Hands Mill Dam 225.01
Washington

MEMORANDUM

TO: To The File
FROM: Steven Hanna, Dam Safety Engineer
DATE: December 9, 2016
SUBJECT: Inspection of Hands Mill Dam, Washington.

79-15-25

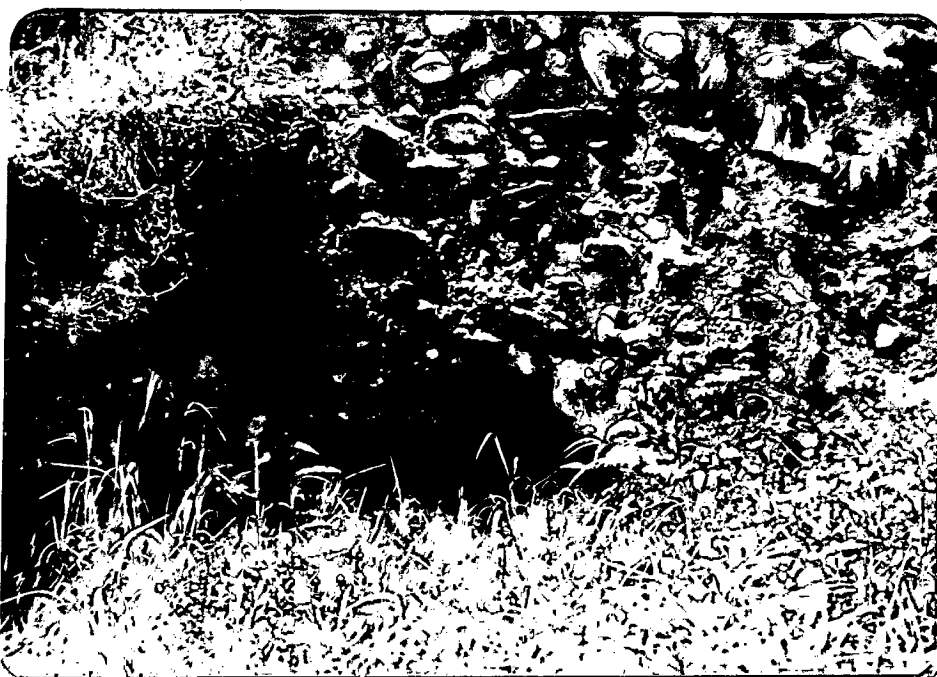
INDS MILL DAM Washington

79-15-24 ~~SPILLWAY~~ BREACH

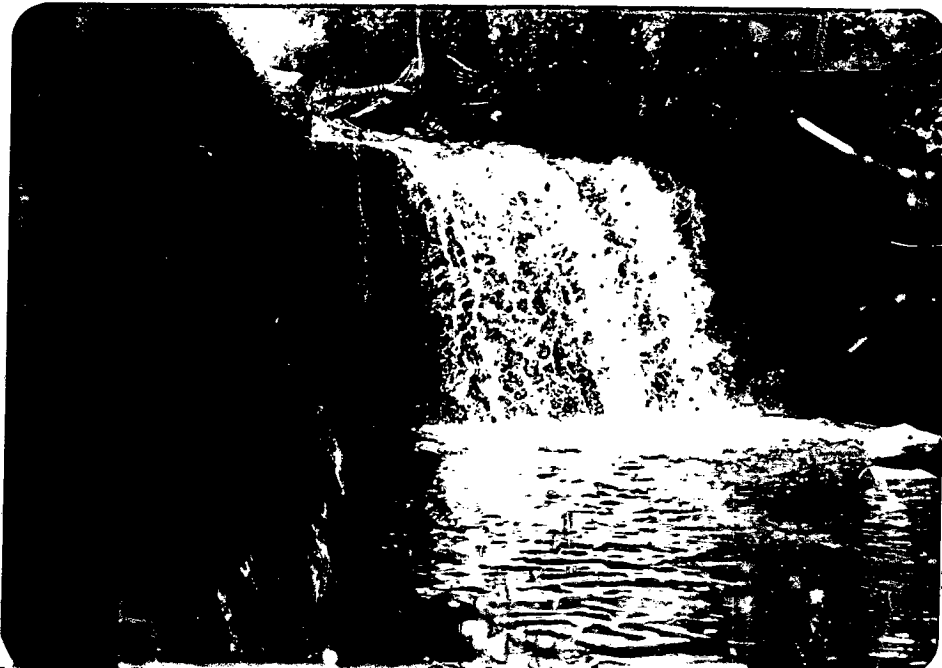
LOOKING DOWN VIS ~~VIEW~~ OF
~~SPILLWAY~~ BREACH TO LEFT OF SPILLWAYS
